The amendment changes the Technical Specifications to establish revised safety and operating limits for operation of Brunswick Unit No. 2 during fuel Cycle Number 5.

BRUNSWICK STEAM ELECTRIC PLANT, UNIT NO. 2

AMENDMENT TO FACILITY OPERATING LICENSE

Amendment No. 71  
License No. DPR-62

FIGURE 3.2.1-1

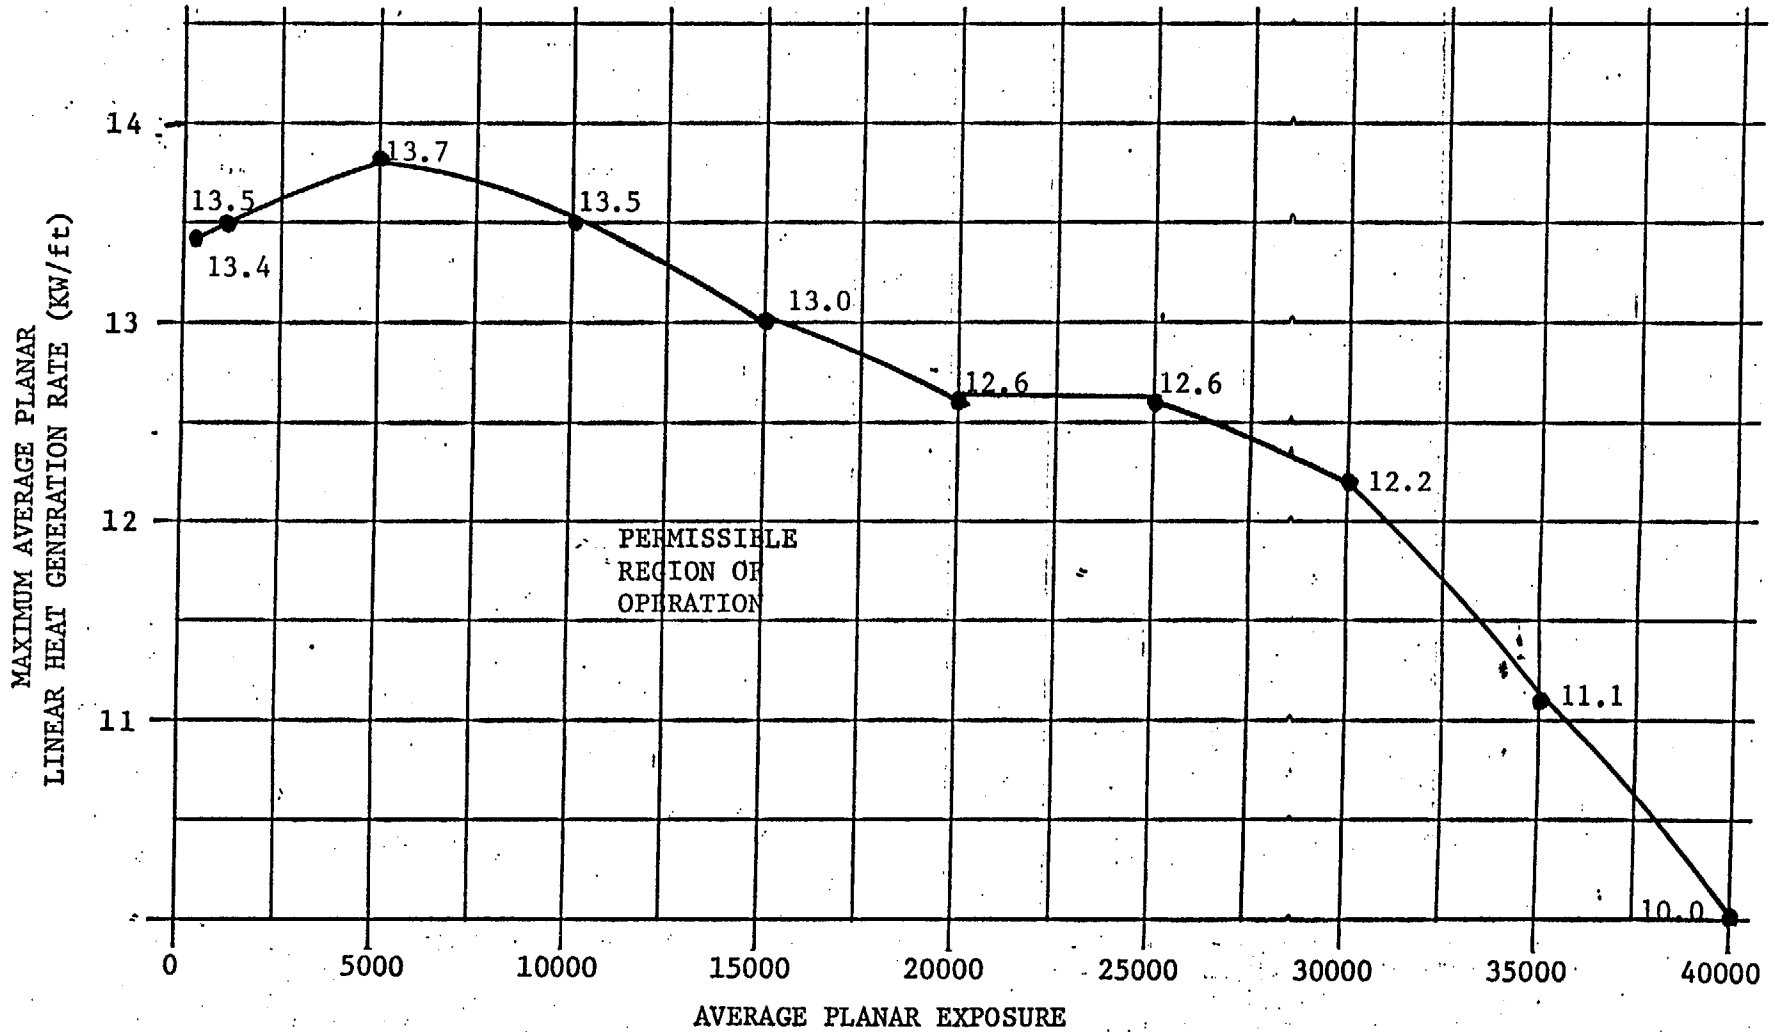
\* These limits differ from those found in General Electric reports Y1003J01A37, March 1982, "Supplemental Reload Licensing Submittal for Brunswick Steam Electric Plant, Unit 2, Reload 4," (with and without RPT) due to a MAPLHGR reduction penalty imposed by NRC due to core spray sparger cracking.

NOTE: See Footnote for Specification 3.2.1

FIGURE 3.2.1-2

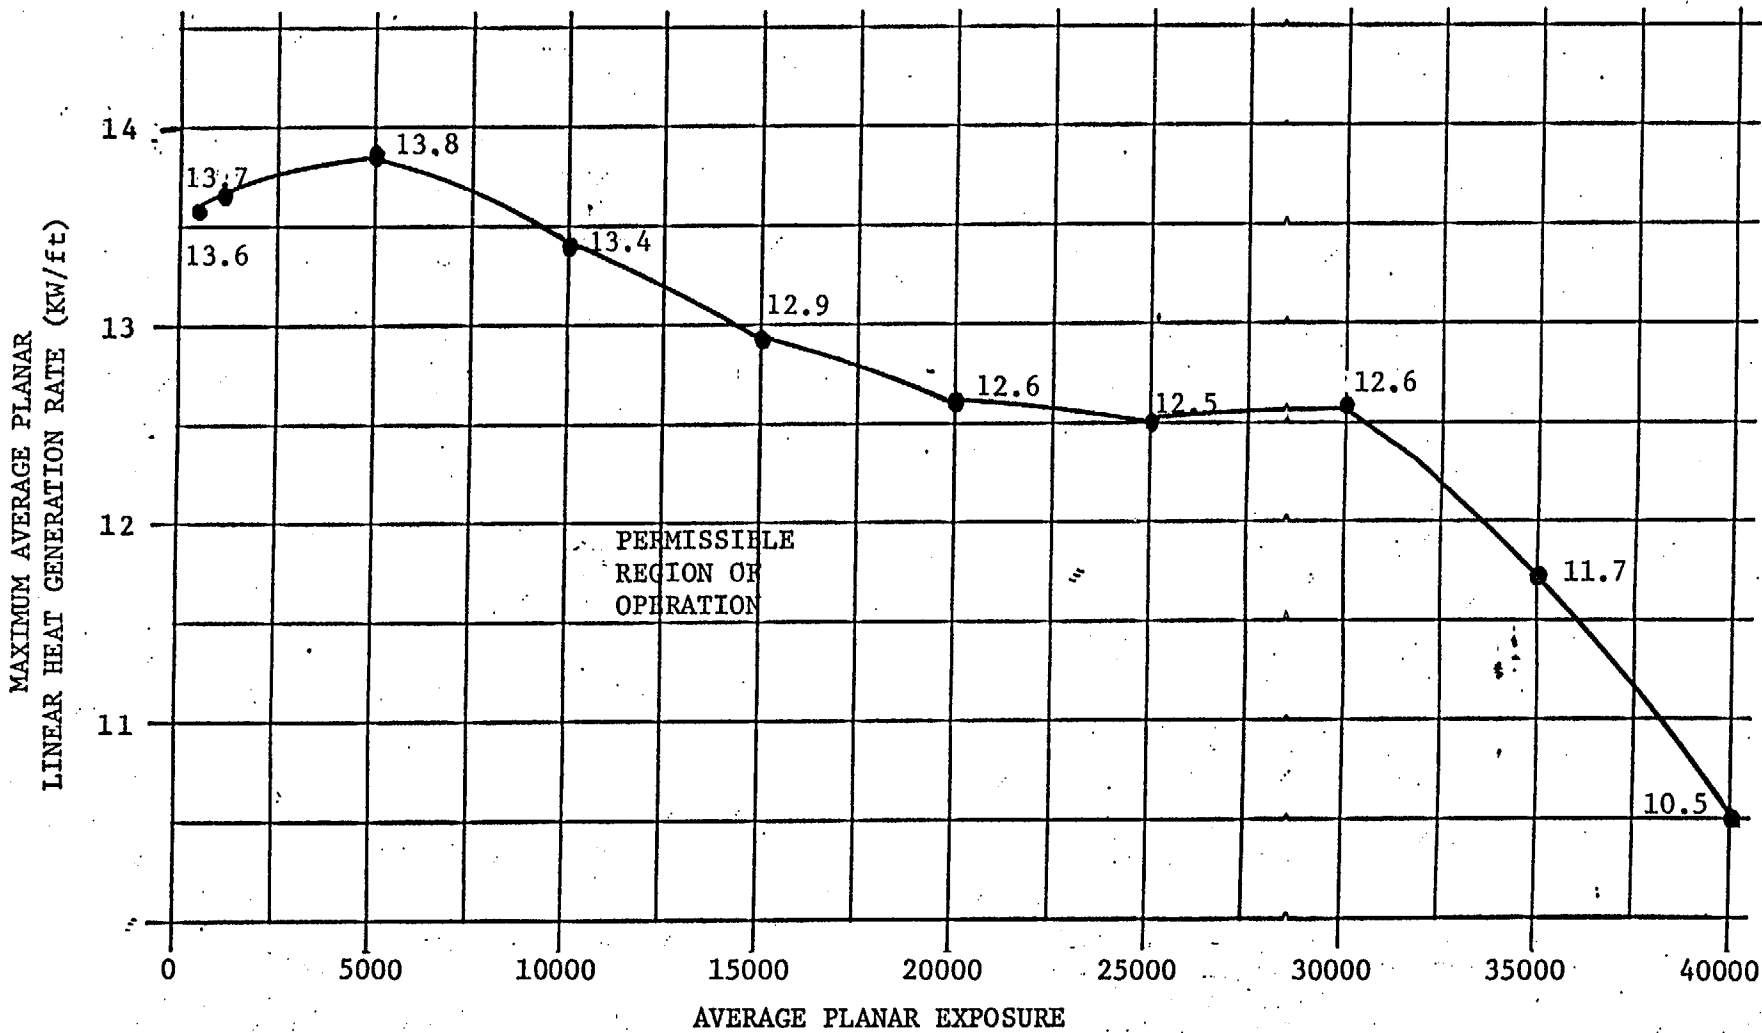
NOTE: See Footnote for Specification 3.2.1

FIGURE 3.2.1-3

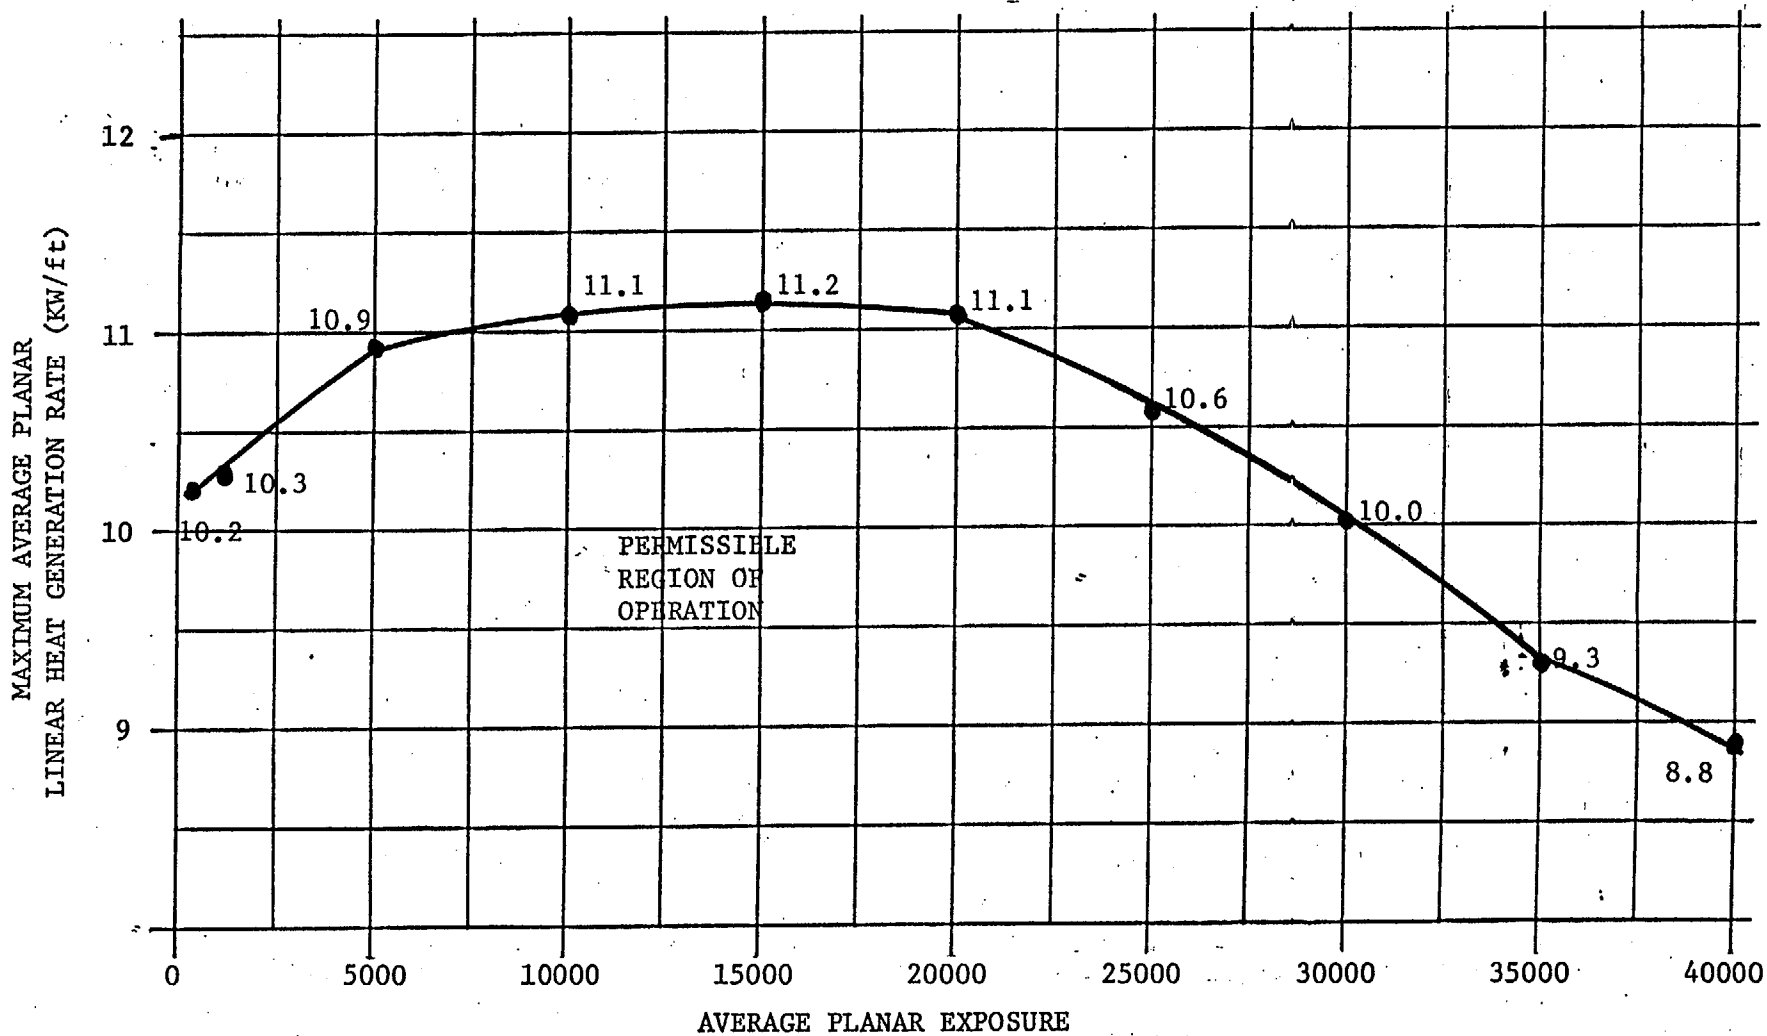
\* NOTE: See Footnote for Specification 3.2.1.

FIGURE 3.2.1-4

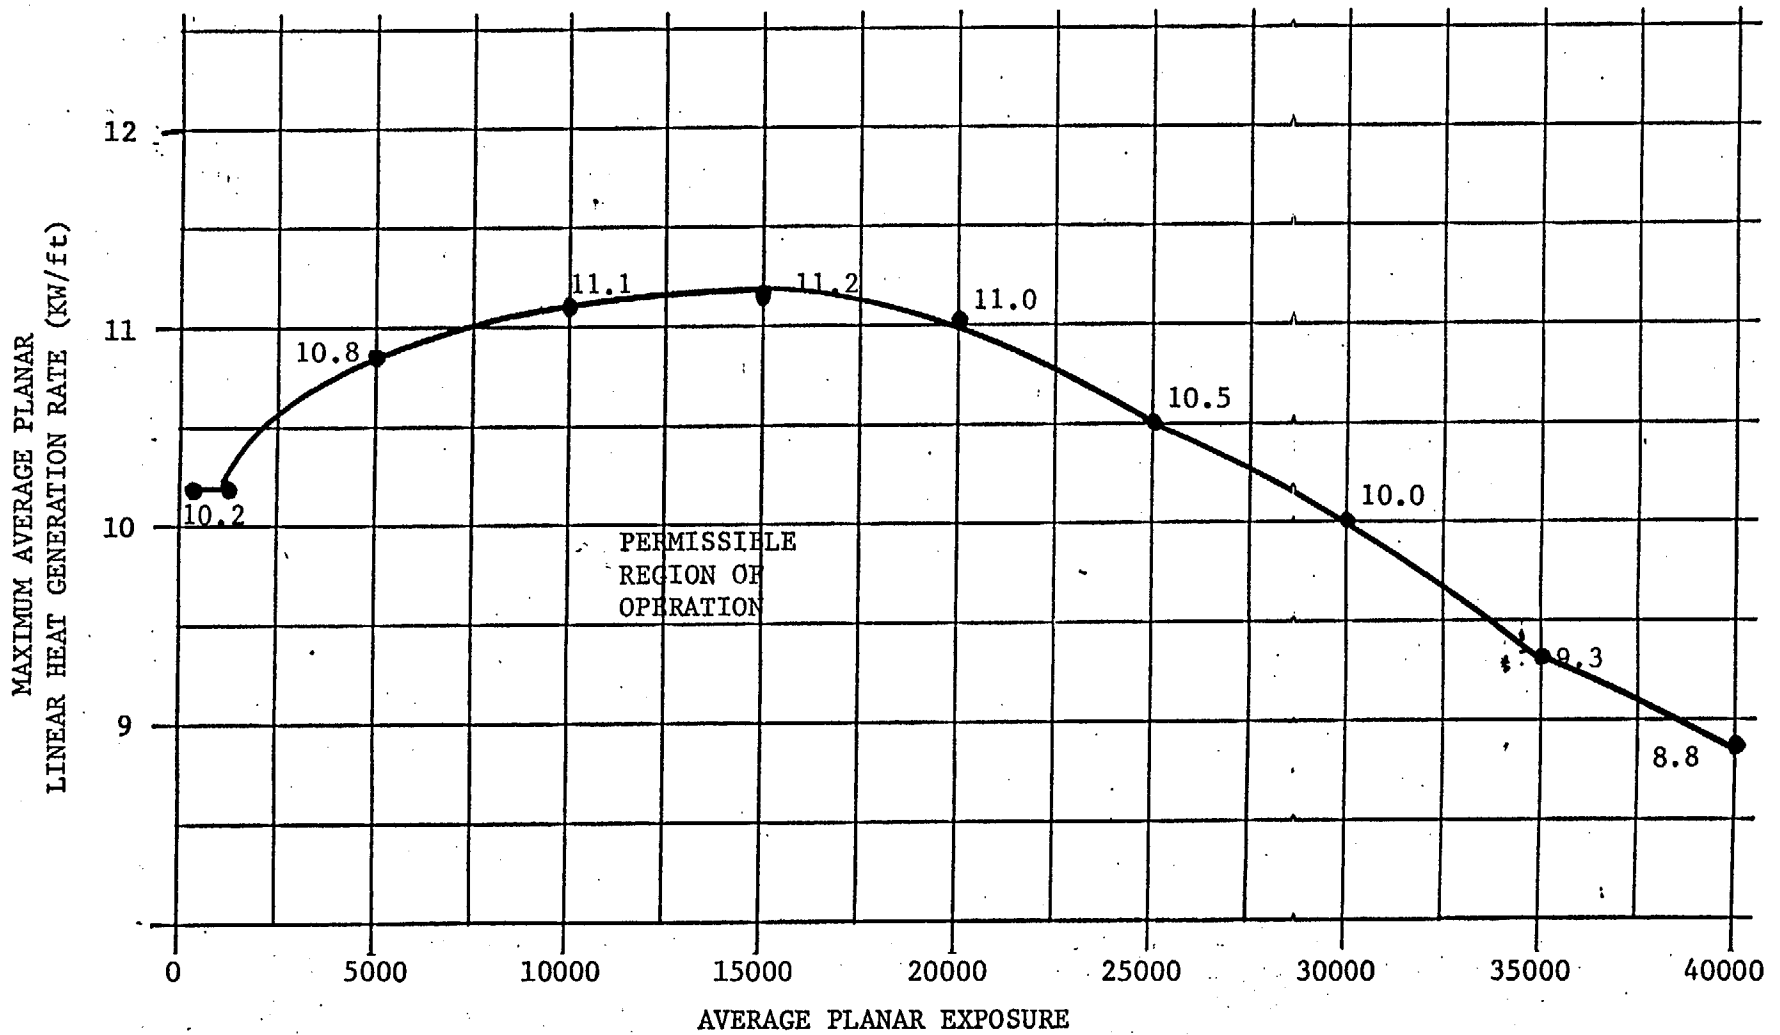
NOTE: See Footnote for Specification 3.2.1.

FIGURE 3.2.1-5

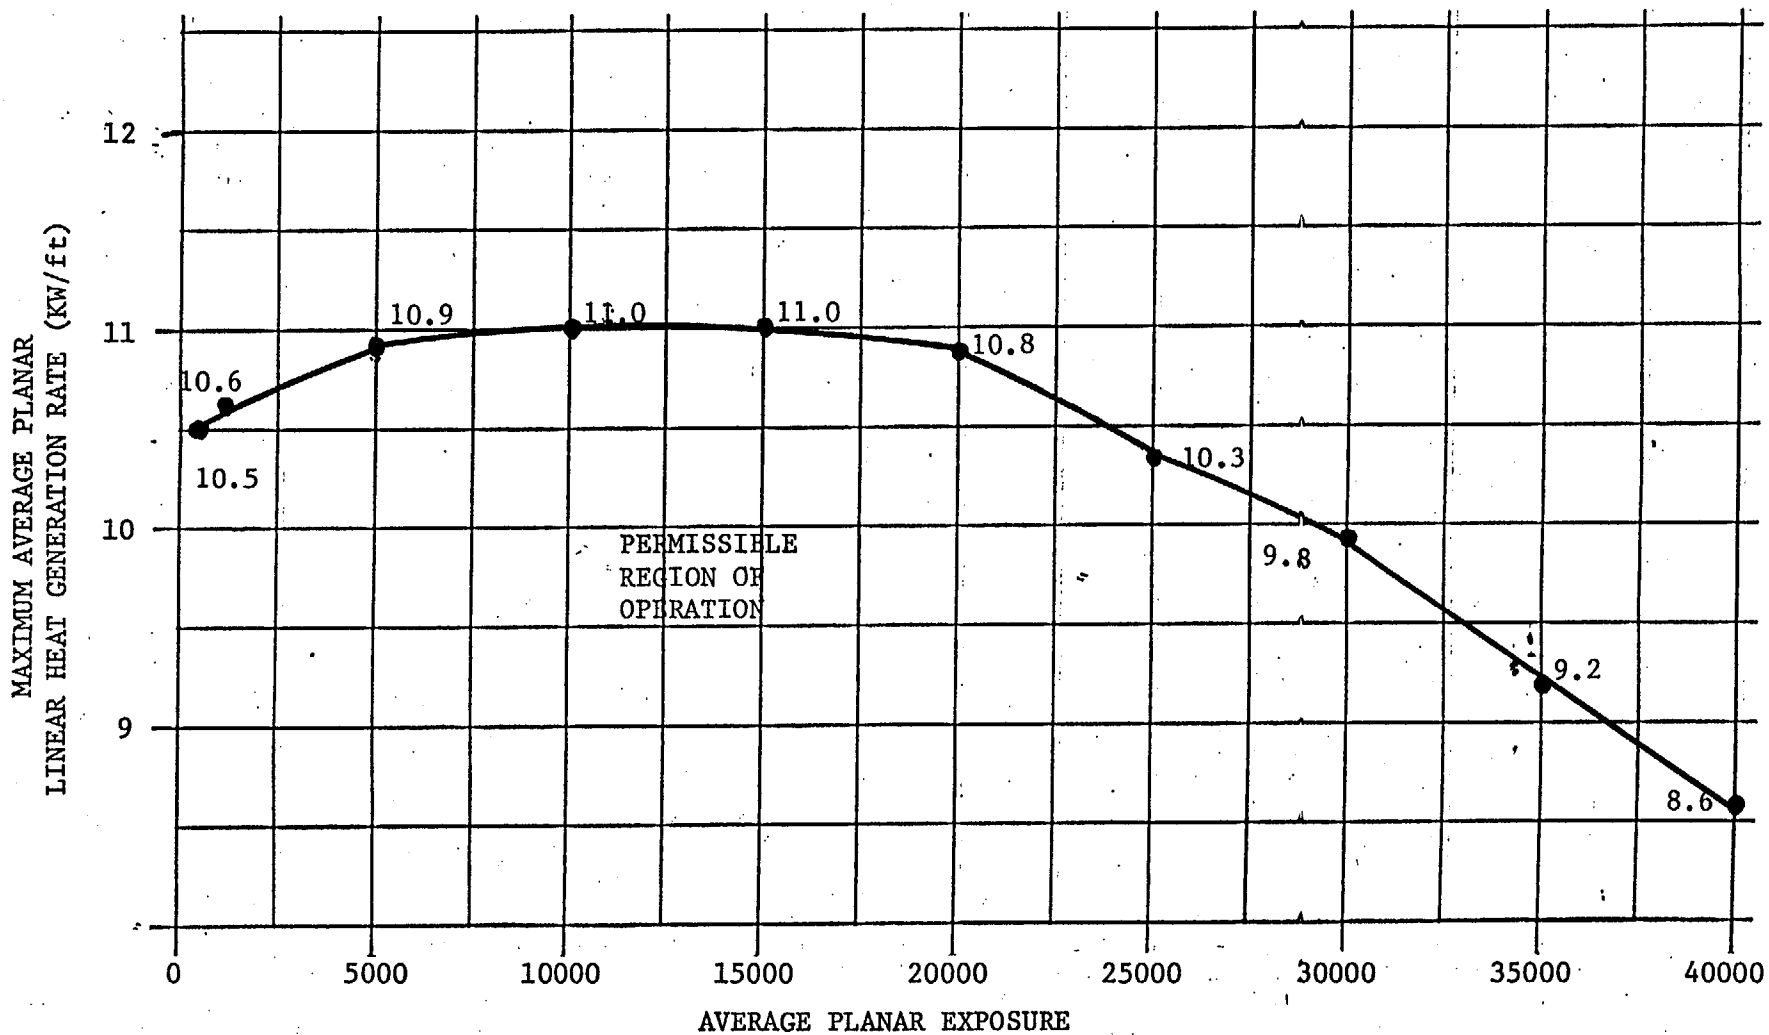
NOTE: See Footnote for Specification 3.2.1.

FIGURE 3.2.1-6

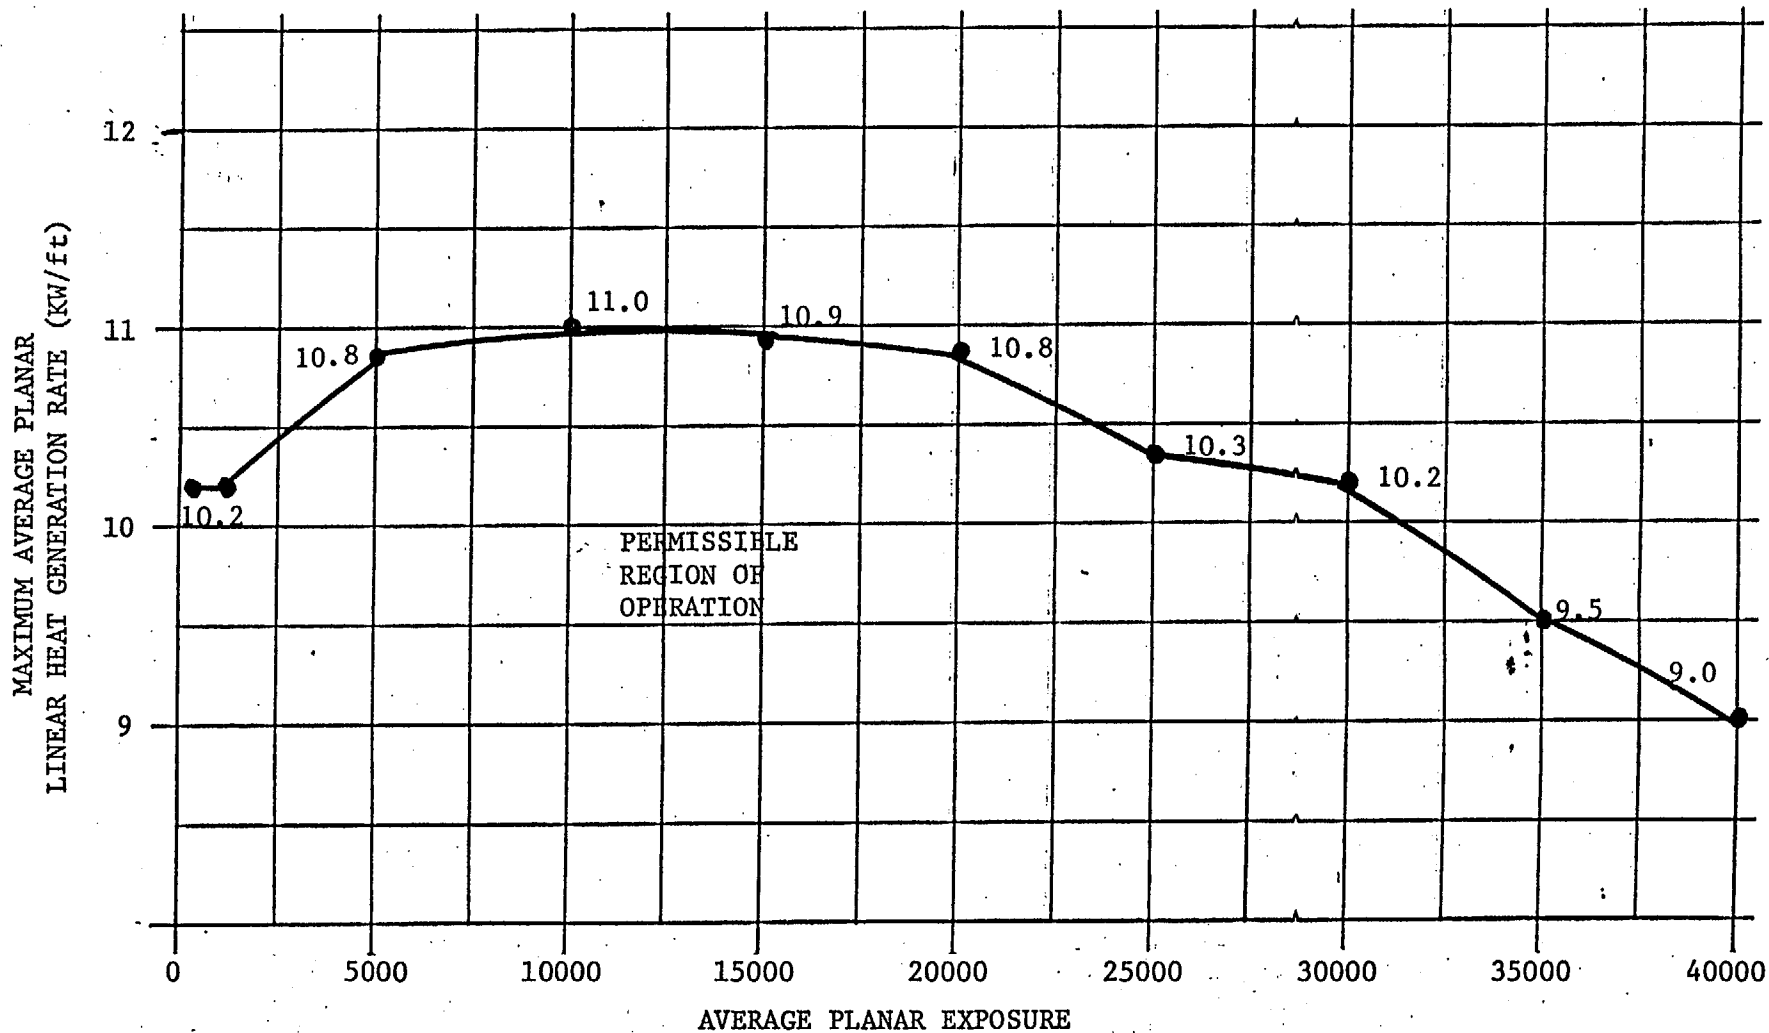
NOTE: See Footnote for Specification 3.2.1.
